Central Planning Authority

Minutes for a meeting of the Central Planning Authority to be held on **June 8, 2022 at 10:00am** in **Conference Room 1038, 1st Floor, Government Administration Building, and Elgin Avenue.**

CPA/15/22

Figure 1: 2018 aerial imagery showing the development (seawall line shown in orange) in relation to the historical (established) vegetation line (Source: LIS 2018).

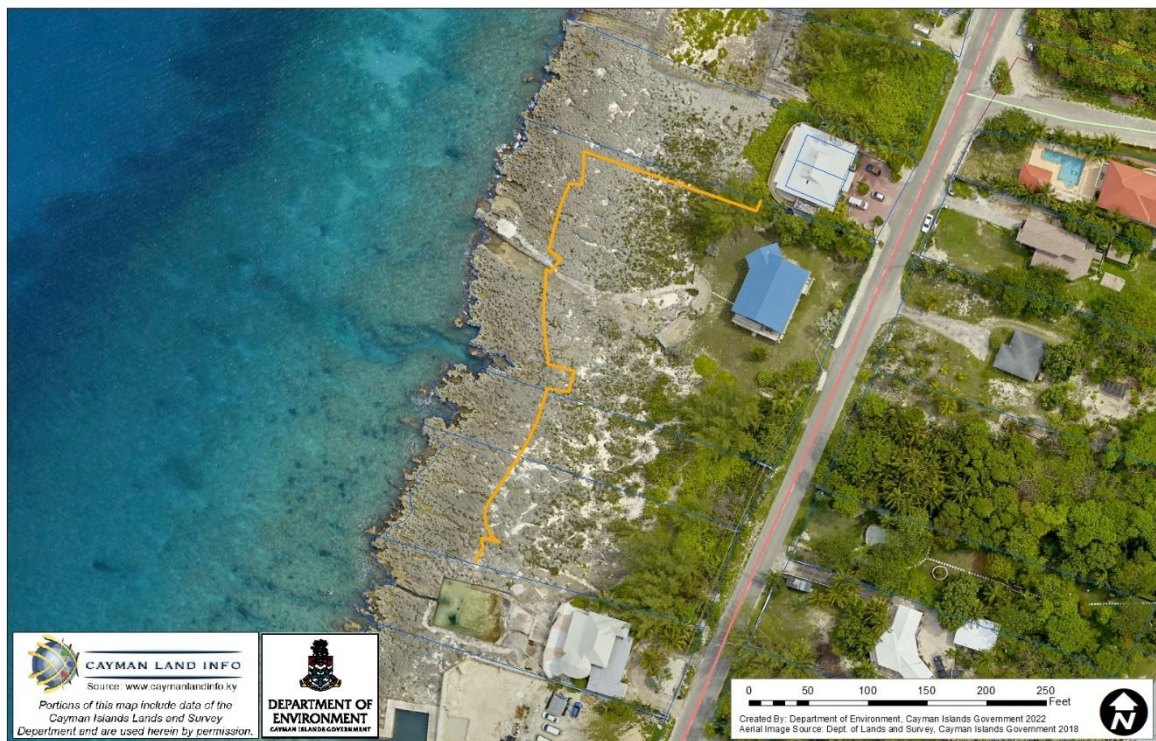
Whilst the application has met the 50-foot coastal setback required in the Development and Planning Regulations, we note that the proposed development would be located closer seaward than that of the neighbouring developments. The subject parcel's coastline highlights the need for site-specific consideration of setbacks instead of an

The natural/permanent vegetation line of the subject parcel is a good indicator of the energy of the coastline and the incursion of the sea on a regular basis. Figure 1 shows the historical vegetation on-site in 2018 and the proposed building setback line in orange; development that is situated seaward of the approximate historical vegetation line increases its vulnerability to flooding and storm damage.

The DoE also recommends that the ironshore coastline be left in its natural state. Aside from forming an important habitat, ironshore assists with the damping of wave energy and represents a unique and visually appealing vista. Developing directly on or driving heavy machinery over the ironshore removes much of these important physical and aesthetic characteristics and leads to the creation of fine material which risks causing turbidity in the marine environment due to surface water run-off. Although the plans do not show any proposed structures seaward of the 50ft setback on the ironshore, the artist’s impressions that accompany plans do show what appears to be a concrete foot path along the northern section of the parcel toward the ocean. It is unlikely that the DoE would support a second concrete path along the ironshore as there is an existing

- The ironshore outside of the proposed built footprint and seaward of the seawall shall be left in its natural state undisturbed by heavy machinery or any other works including pouring of concrete pathways etc. Any proposed modification of the ironshore, including the resurfacing of the existing ramp and concrete path, should be the subject of a separate consultation with the National Conservation Council.

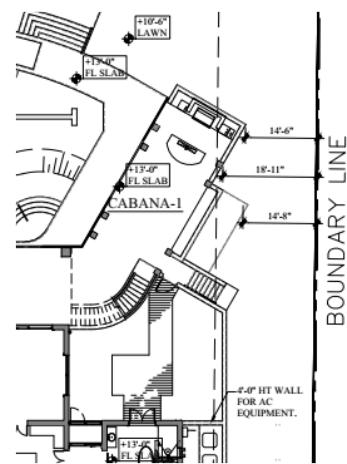
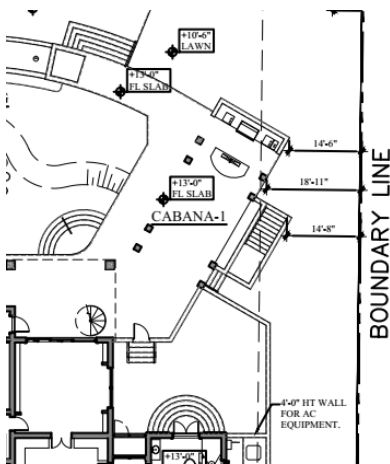
It was decided to change the stairway access to the pool equipment room. Instead of having the approved and permitted basement stairs which were orientated to face the ocean, and thus might allow potential flooding of the pool equipment and storage space in time of storm, the grading on the east side has been reprofiled such that you can walk straight into the pool room rather than go down a “basement” like stairway.

The applicant seeks the CPA’s formal re-approval of those elements projecting into the east side setback and to include the reconfiguration of the stairway leading down to the equipment room under the BBQ Cabana.

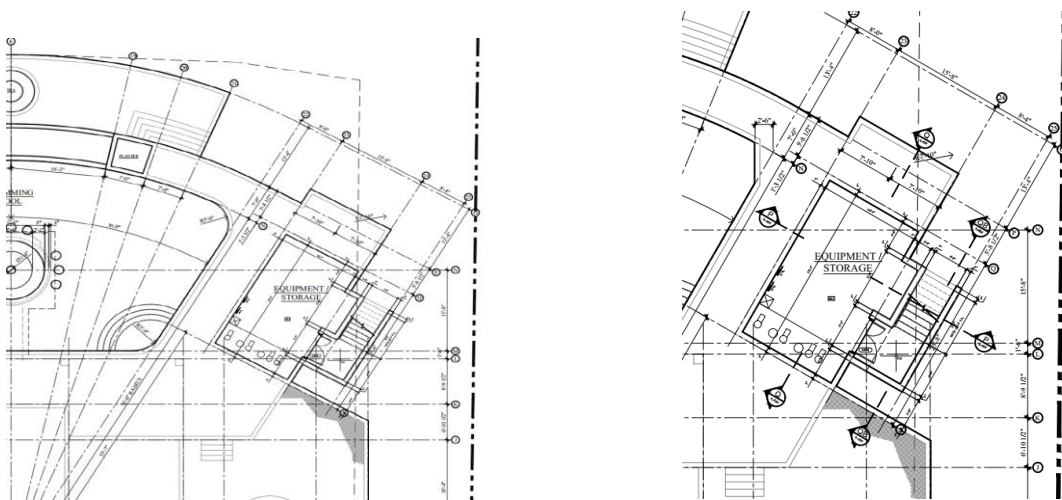
The minutes of CPA 11/22 item 2.16 appear to suggest the basement area under the pool cabana is an “after the fact” addition, which is not at all the case.

Figure 1: DOE's 2013 Habitat Map extract showing the application site outlined in red and the proposed land clearing footprint in purple (hashed lines).

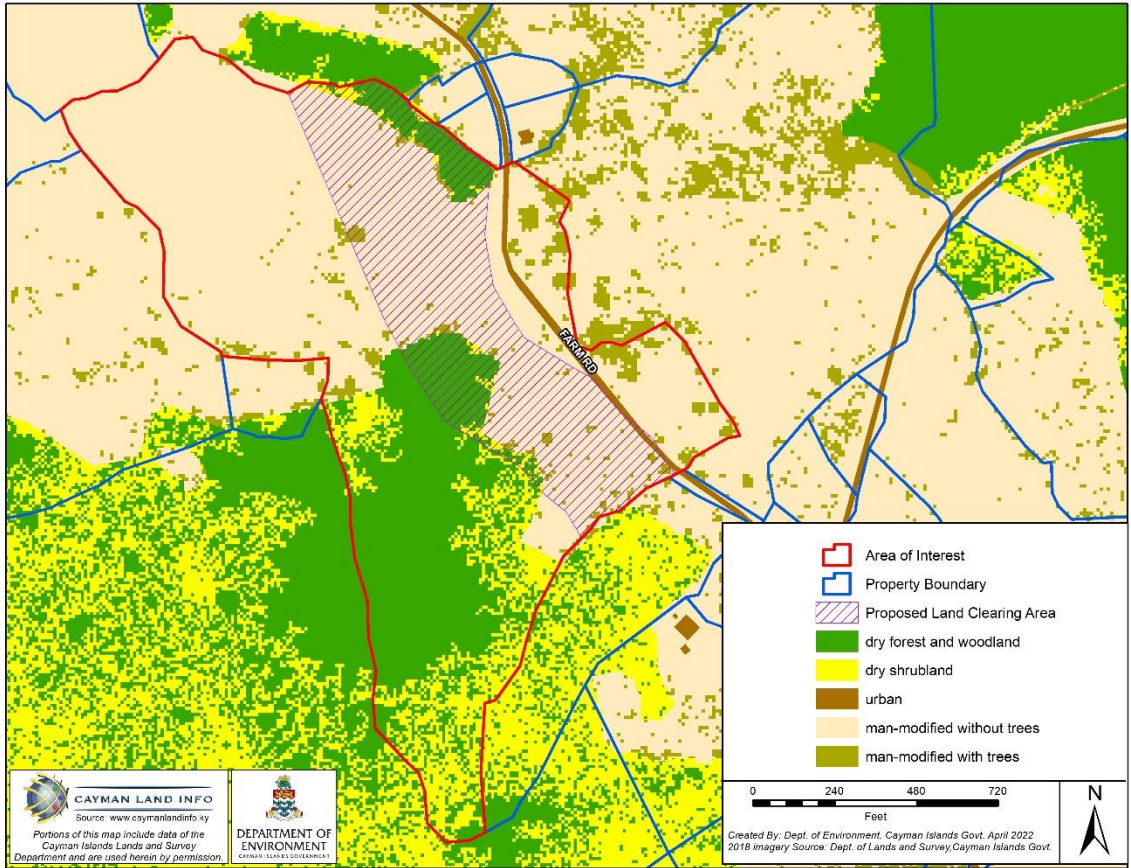
The application site consists of a mixture of primary dry forest and shrubland habitat and man-modified areas as shown in Figures 1 and 2. Primary habitat is mature habitat in its natural state, otherwise uninfluenced by human activity where ecological processes are not significantly disturbed. These habitats are often very old, existing long before humans and may consist of many endemic and ecologically important species. These habitats are becoming rarer due to conversion from human activity and are under increasing pressure from climate change induced threats.

Figure 2: LIS 2018 aerial imagery showing the application site outlined in red and the proposed land clearing footprint in purple (hatched lines).

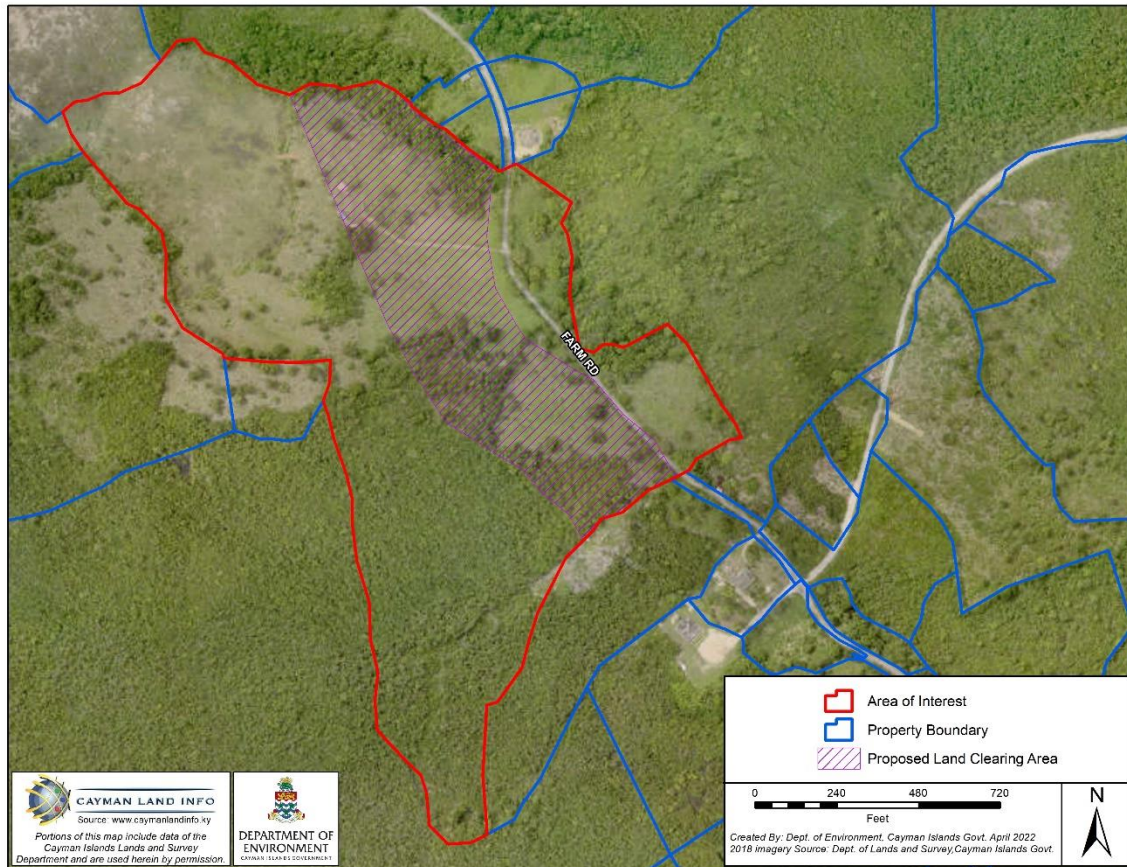
The impacted areas appear to have been used for farming in the past. However, the application site is likely in the habitat range of the Grand Cayman Blue Iguana (*Cyclura lewisi*). Blue Iguanas are listed as endangered on the IUCN Red List and they are a Part 1, Schedule 1 protected species under the National Conservation Act (2013) making them a species ‘protected at all times’. Blue Iguanas are endemic to Grand Cayman meaning they are unique to Cayman and found nowhere else on earth. They are an iconic Caymanian flagship species and their presence serves as a valuable tourism asset.

Figure 1: LIS 2018 aerial imagery showing the application site outlined in red.

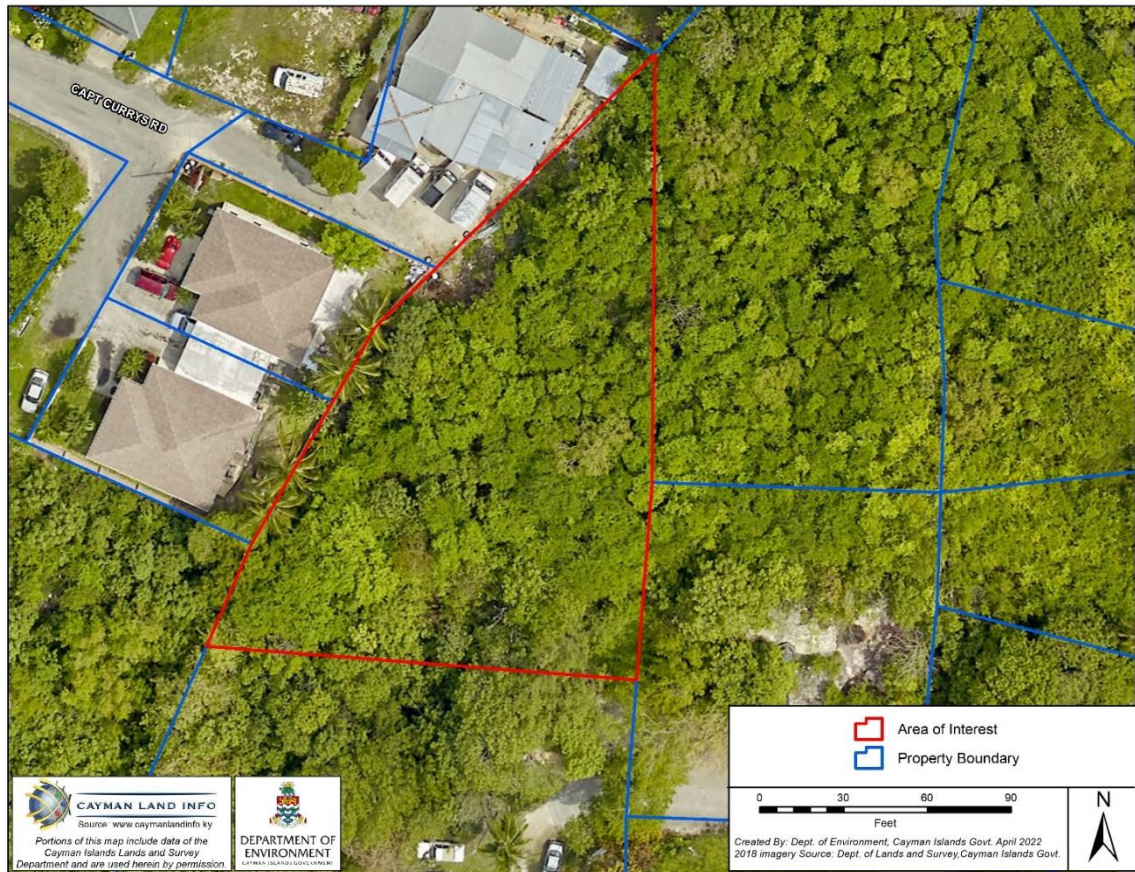
The application site is man-modified with secondary regrowth as shown in Figure 1.

*There has been no rationale provided for the land clearing included in the applicant’s submissions, therefore, the DOE considers the proposal to be speculative clearing. The DOE does **not** support speculative clearing of parcels prior to planning permission for development being granted. We recommend that applications for land clearing are presented along with the development proposal so that appropriate mitigation measures can be recommended, as there may be varying recommendations depending on the form and nature of the development being proposed. Once planning permission has been received, the DOE encourages applicants not to undertake land clearing until development is imminent to allow ecosystem services to continue to function until they are ready to begin construction. We also encourage applicants to retain as much native vegetation as possible to incorporate into the landscaping scheme. Native vegetation is best suited for the habitat conditions of the Cayman Islands, requiring less maintenance and less supplemental irrigation. Once it is established, landscaping with native vegetation is a very sustainable and cost-effective choice.*

Figure 1: Aerial imagery showing the subject parcel (Source: Lands and Survey 2018)

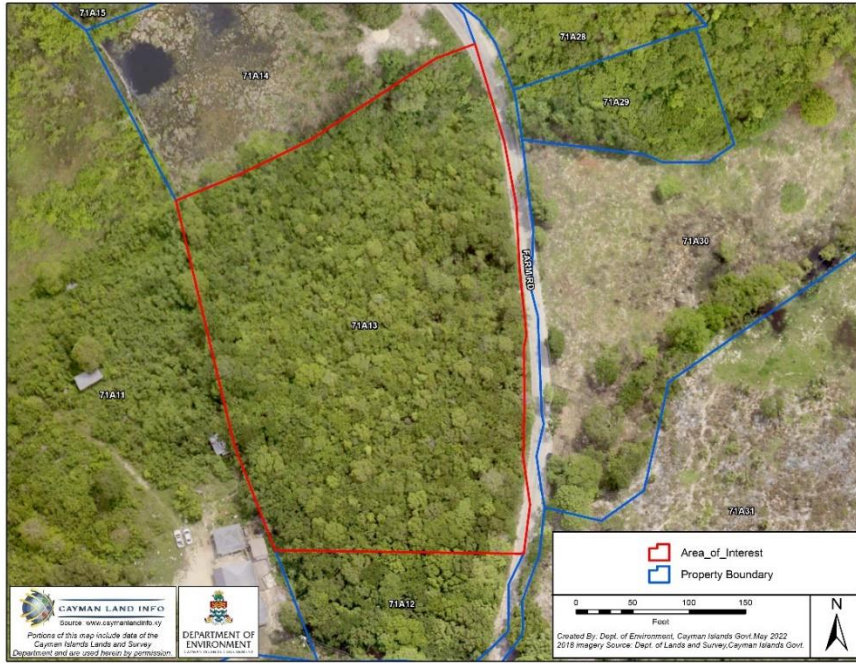
The Department notes that the subject parcel is man-modified with regrowth as shown in Figure 1 below. A review of the Lands and Survey Department's historical aerial imagery confirmed that the site was previously cleared; possibly to be used as a pasture lands in the 50s. However, there has been significant regrowth over the decades and the DoE would not support the clearing of the parcel at this time as we do not support speculative or wholesale clearing of subdivision sites.

In principle, land clearing should be reserved until the development of individual lots is imminent (through the granting of planning permission for development on those particular lots). This allows the opportunity for the individual lot owners to retain vegetation and allows the site to continue to provide ecosystem services such as providing habitat for wildlife, assisting with stormwater management and storing carbon.
